Community and Economic Development

Staff Use Only: Candlewood Suites			
Project Name:			
Master Project #: CUP22-0001	Sub-Projects #: SEP22-0004	Pre-Application #/Date:

Re: REVISED RESPONSE TO COMMENTS - CUP22-0002, SEP22-0004: Major Conditional Use Permit, SEPA; Candlewood Suites; Comment Letter 1
14831 Military Rd, Seatac, WA 98037-6627

A1.0 SITE PLAN

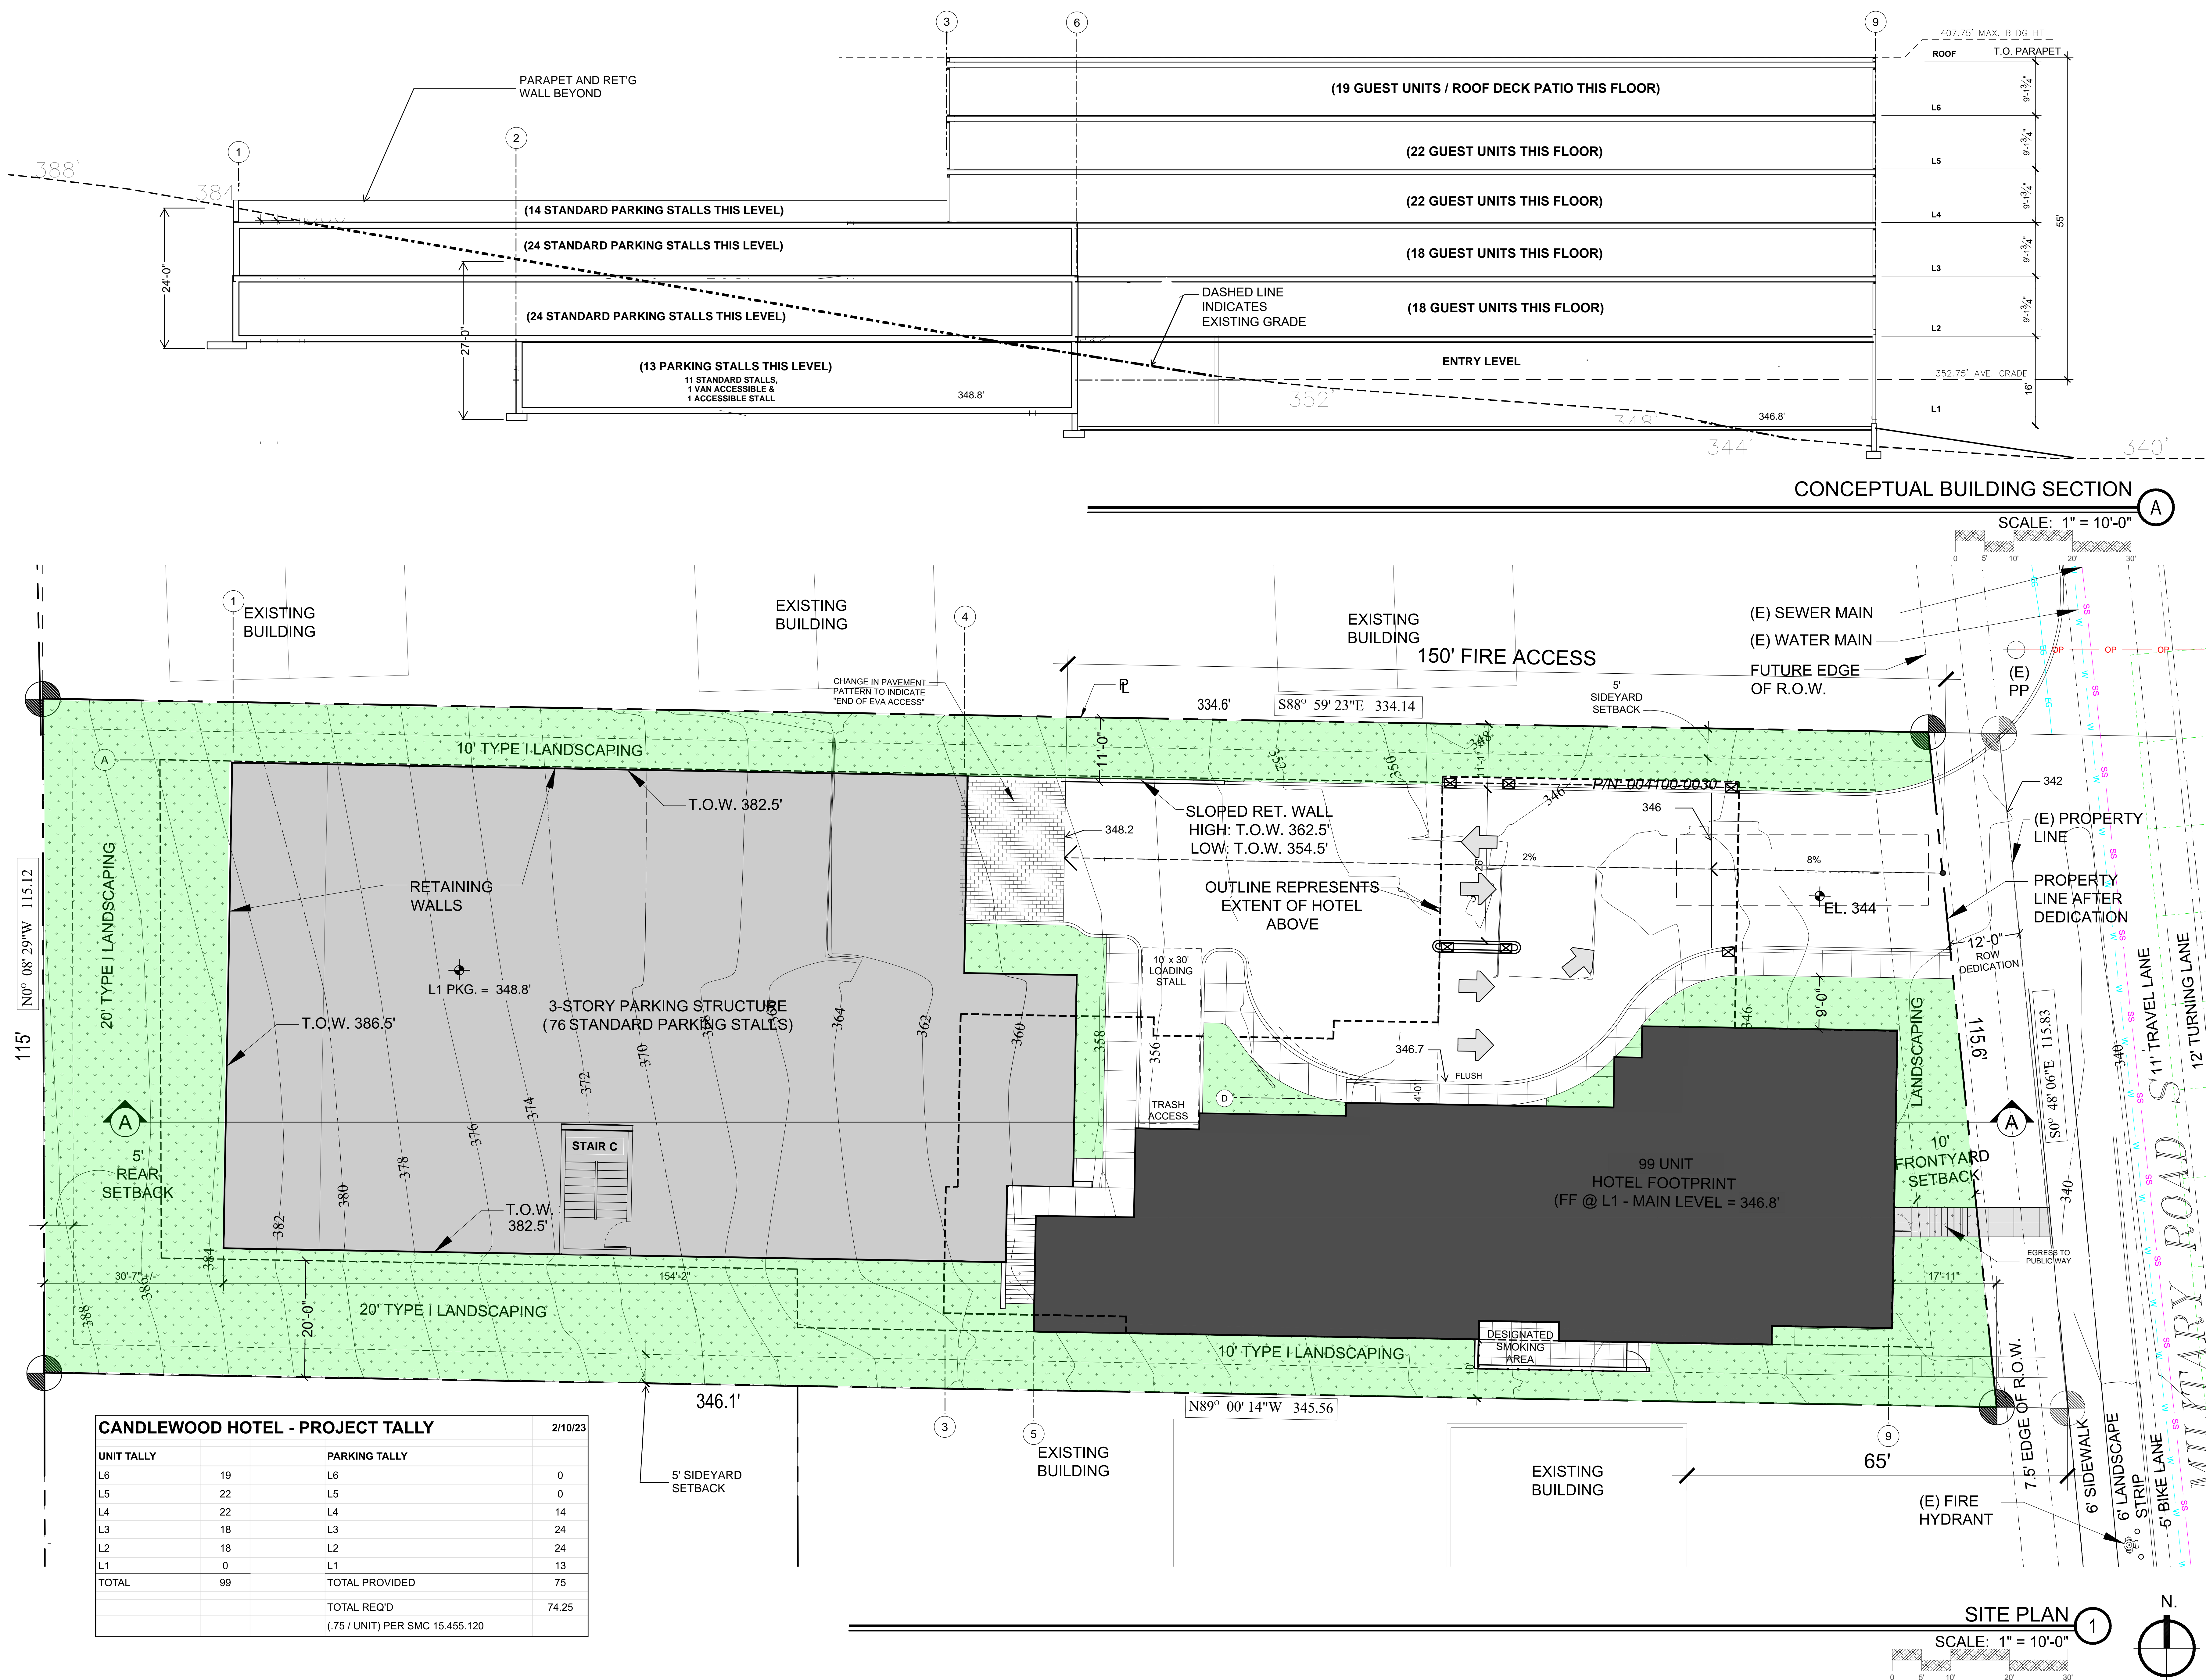
1. The site configuration on Sheet L-1 doesn't match configuration on A1.0. On sheet L-1, the hotel is approximately 20' shorter in length, there are only 3 parking spaces adjacent to the north façade, and the gazebo is shown on the entry plaza.

4. The loading space adjacent to the garbage enclosure doesn't meet the required dimensions of 10' by 30' [SMC 15.455.200(D)].
Response: The loading space has been adjusted to meet the minimum requirements, see sheet A1.0 for clarity.

Response: The revised landscaping sheet L-1 has been coordinated with the architectural site plan, and is showing the current building configuration.
2. The location of the trash enclosure needs to be approved by Recology CleanScapes (contact is Steve Aiton, 206-499-1481, saiton@recology.com).

LANDSCAPE PLAN

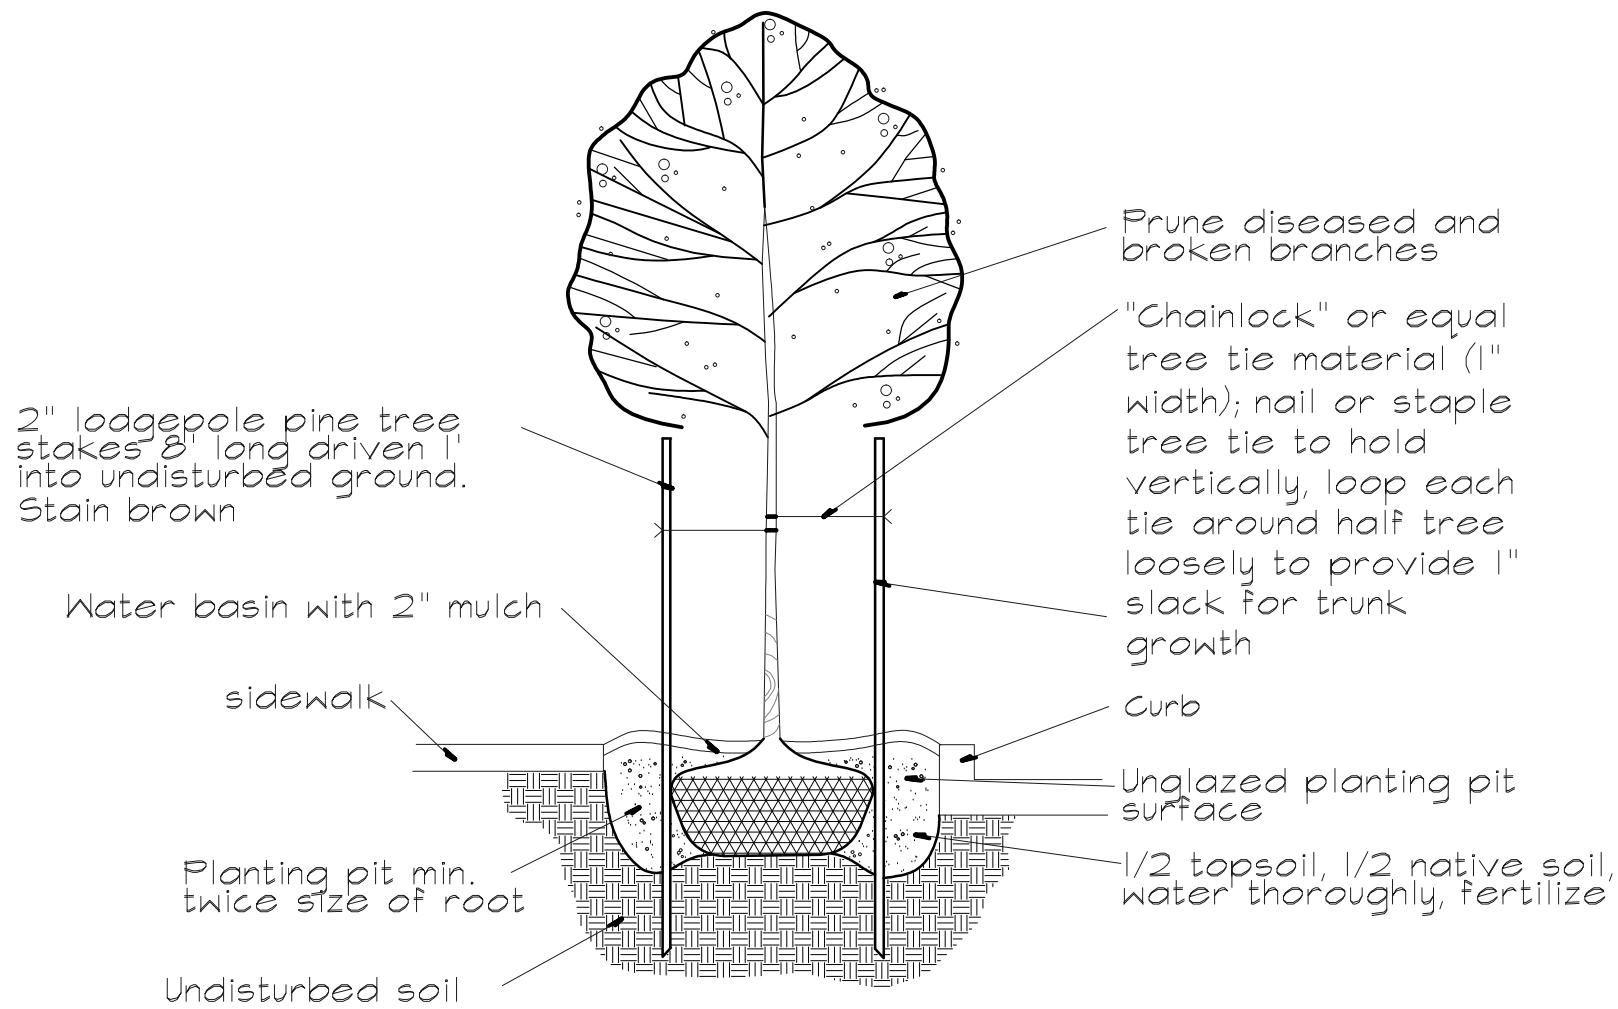
Response: The project design has been revised to include 20' of type I landscape buffer at the West and a portion of the southern property line.
 - B. The landscaping types (e.g. Type I, II) are not shown on Sheet L-1.

Response: Landscape types are now called out on revised L-sheets.

Response: Additional landscaping has been added to the site plan, also see sheet L-1 for clarity

A3.1 EXTERIOR ELEVATIONS

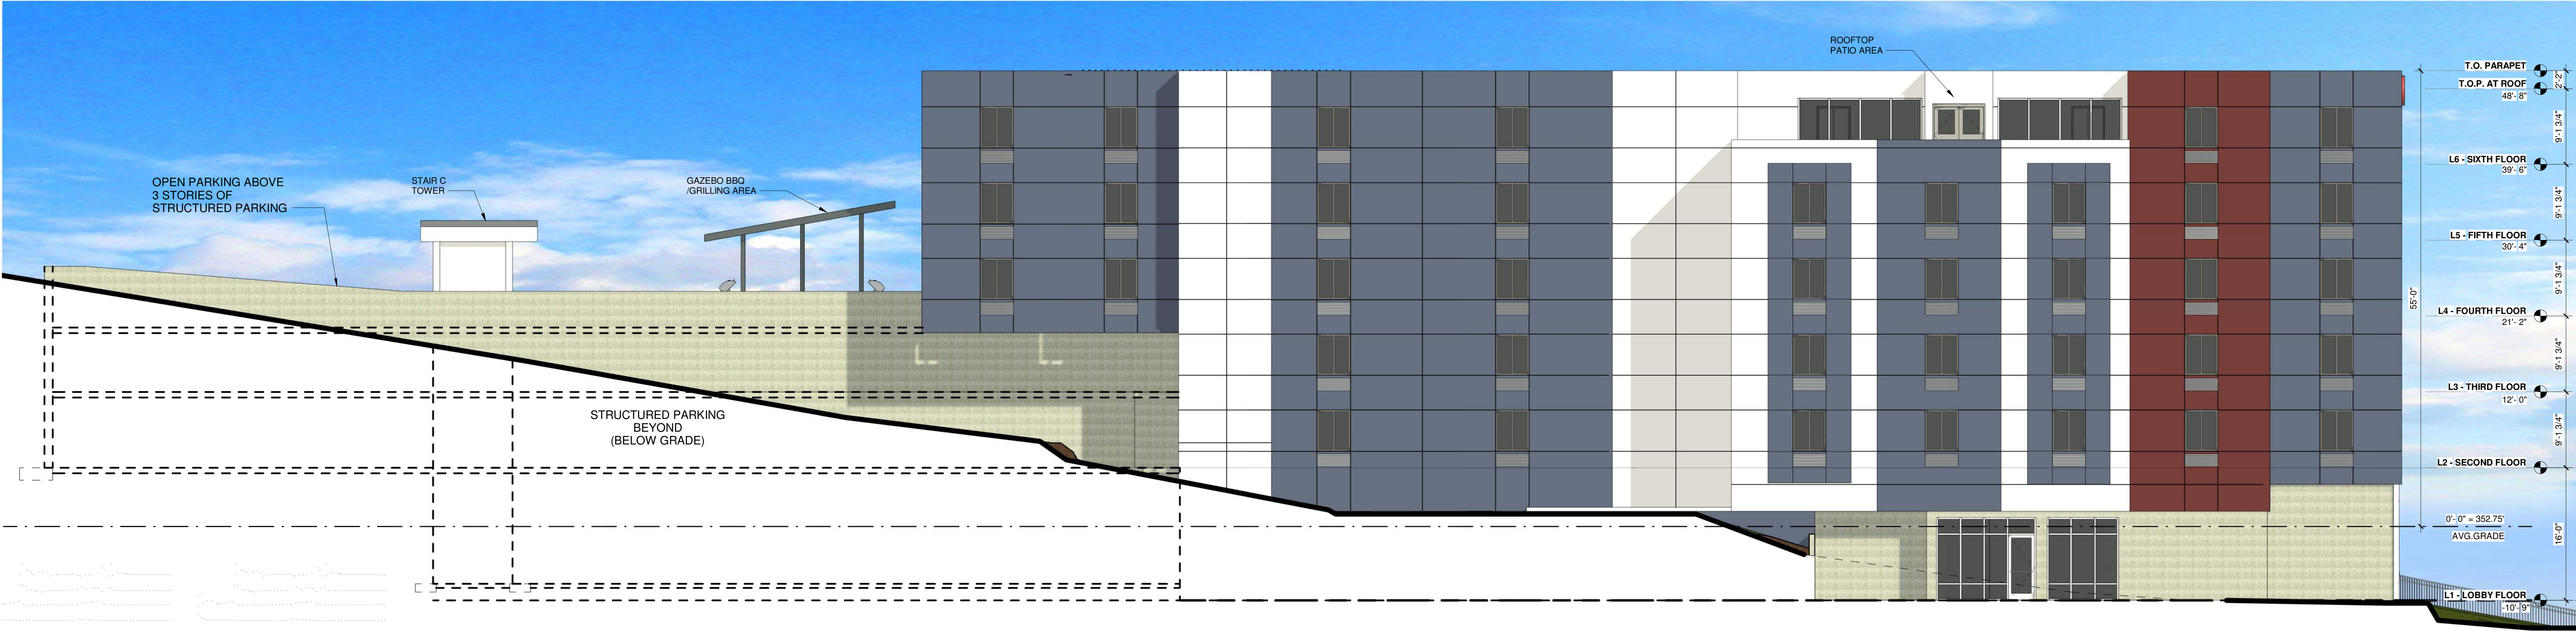
Response: The trash enclosure has been relocated and coordinated with Recology CleanScapes for both access and scheduling.
3. The parapets on the north facade exceed the maximum height limit of 55'. Parapets are only allowed to exceed the maximum height limit when required by building and/or fire code.

Response: The parapet design & height has been adjusted to comply with the maximum height limit of 55' from avg gradet, see elevations on sheet A3.0 for further information.
